Proposed Solar Development at
Birchall Green Farm, Sinton Green

Planning Application Ref: 21/01846/FUL

Landscape & Visual Review

Grimley Solar Farm Action Group

Example of weldmesh security fencing at solar farm

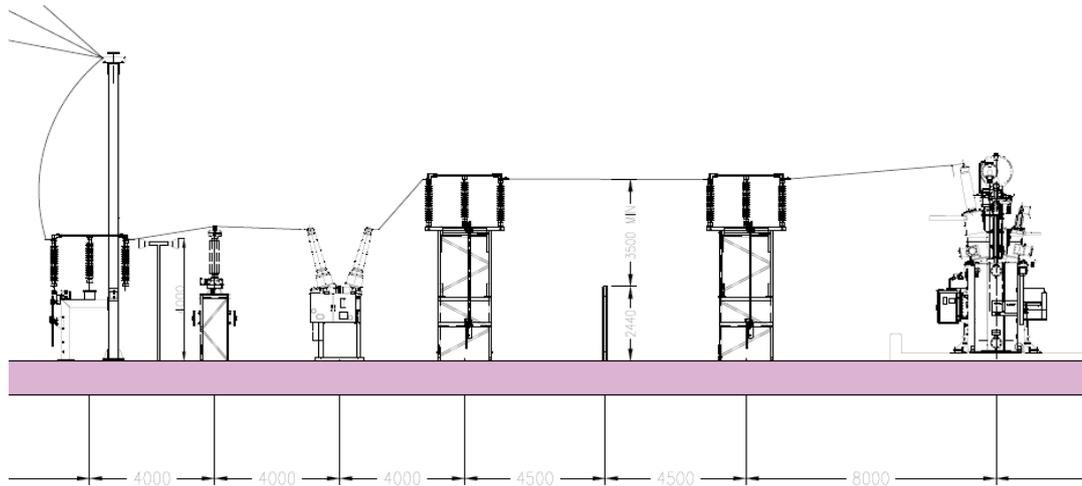
- **MHDC to ask the applicant to clarify which type of fencing would be specified, and what colour, and provide photographic examples of the fencing *in situ***
- xvii) 4m wide x c. 2m high green metal security gates would be situated within the fenceline at the access points. Safety signage would be displayed on the fencing and gates.

Application site boundary at proposed southern access to site east (image © Google)

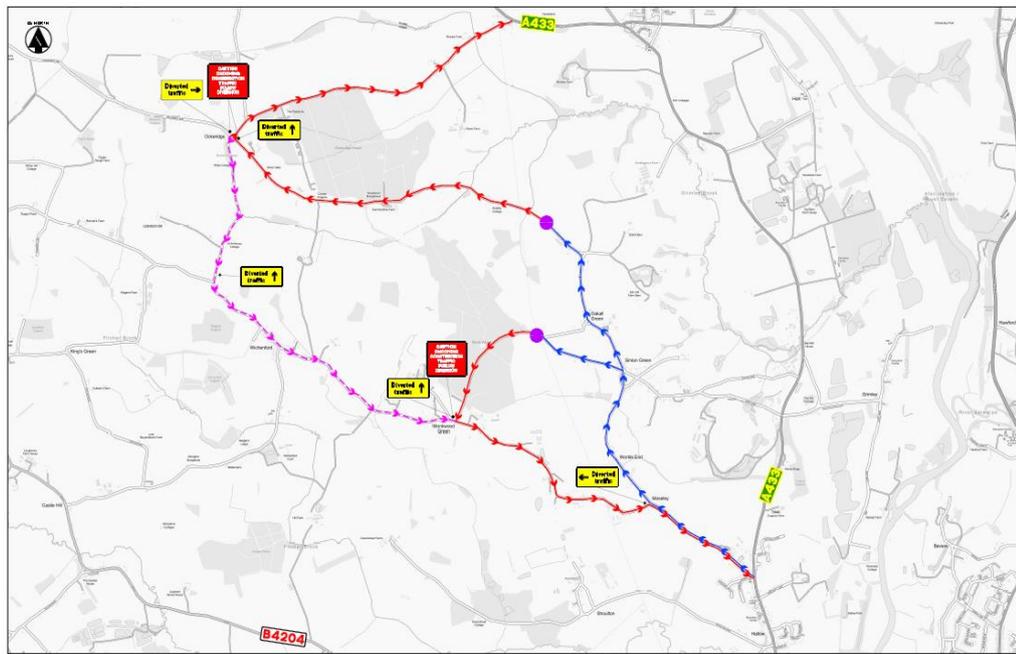
- xlvi) I estimate that a c. 160m-long section of the roadside hedge on the southern side of the lane would have to be removed, along with at least two mature oak and possibly other escaped hedgerow trees including a veteran ash, and an associated c. 160m-long section of grassed verge. If that was the case, presumably the ditch could be diverted, and a new hedge and verge created / trees planted, but as far as I could ascertain, this has not been proposed.

- **MHDC should ask the applicant to confirm whether the lane would be widened and if so, to provide details of the proposals and a full assessment of associated environmental effects**
